Resource consent application LUC 2016-480, 201 Princes Street, Dunedin.

Herewith some further visual information on the possible solutions of lowering the total roof. By adding a roof light over the mezzanine floor.

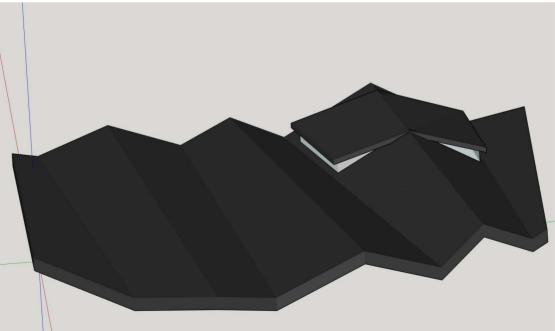
The height of this above the main roof depends on the amount of lowering of the main roof. At this stage it is planned to lower the roof by about 500mm and bring the roof light up by 400mm. Will bring a model to the hearing to show the effect.
